BACHELL AVENUE RFI LETTER – REVIEW AND FEEDBACK

30th SEPTEMBER 2024

The following document has been prepared in response to the Design Excellence Panel meeting minutes issued for the presentation made on the 19th of June 2024. It is also in response to Cumberland Council's Request for Further Information for Development Application DA 2023/0775 dated 30th July 2024.

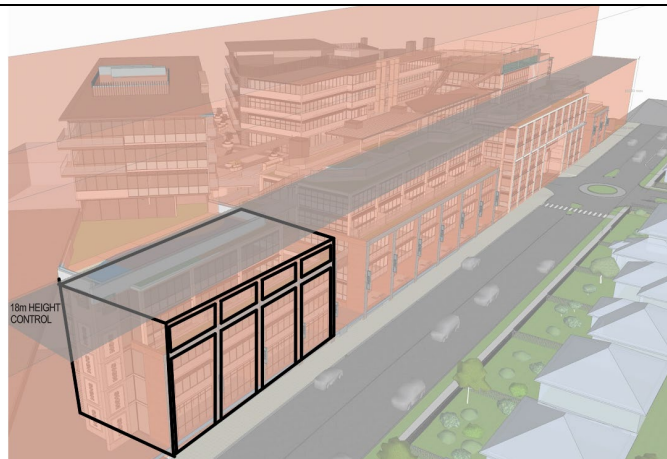
Please design height breaches out of the proposed design – there is no clear reasoning behind why these are required.

The proposal as originally submitted, and as amended by the updated architectural drawing set identifies minor exceedances to the height control, which is 18m for the first 12 metres, and 32m for the balance of the site. The height can be considered as a function of the ground floor RL, and the upper floor massing.

The ground floor RL is established by the flood constraints of the site, and therefore cannot step down to follow the fall of the site, which is approximately 4.5m along the Bachell avenue frontage.

The design consideration of the upper floor massing was to present a repetitive lower scaled form to Bachell avenue, and the taller form recessed from the Bachell avenue frontage. The Bachell avenue fronted massing is further modulated by recessing the fourth and fifth storey.

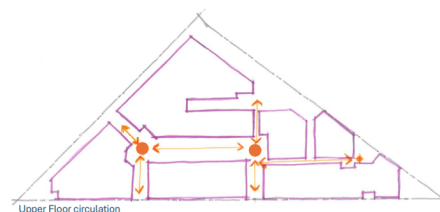
Layout of uses is generally ad-hoc and confusing- it lacks integration between uses and with the local area. Consider how someone visiting the development will want to move around and design to make it as easy (and efficient) as possible. The layout of light industrial uses appears odd – 'back of house', disconnected from the development, yet demands expensive ramp infrastructure to access Level 2. Is there a reason why these uses can't be all on ground floor?

● **GROUND FLOOR** - VERTICAL CIRCULATION NODES SHOWN AS CLEARLY VISIBLE UPON PEDESTRIAN ENTRY POINTS AND ALSO THROUGH CIRCULATION ZONES

● **UPPER FLOORS** - VERTICAL CIRCULATION NODES SHOWN AS CLEARLY VISIBLE UPON PEDESTRIAN ENTRY POINTS AND ALSO THROUGH CIRCULATION ZONES

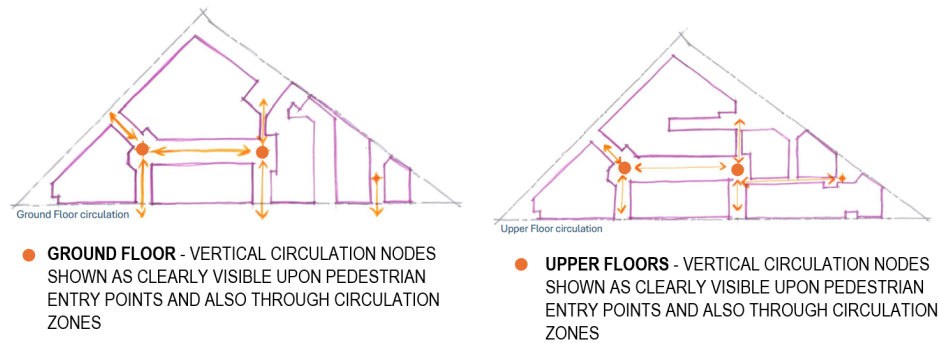
Understanding that the intention is that the ground floor tenancies are dual frontage, stairs and retaining walls at the street frontage are to be avoided. Review level of ground floor slab.

The ground floor RL is set at the flood planning level. Additionally, there is approximately 4.5m fall along Bachell avenue. Along CG.01 to CG.06, retaining walls are required to the outdoor seating areas, punctuated by openings to draw people into the tenancies, providing activation. At the point where a retaining wall would be the highest, along AG.01 and AG.02, the shopfront glazing is brought down to the footpath level, with the height transition occurring within the tenancy. This provides for a display along the frontage, appropriately activating this end of the development.
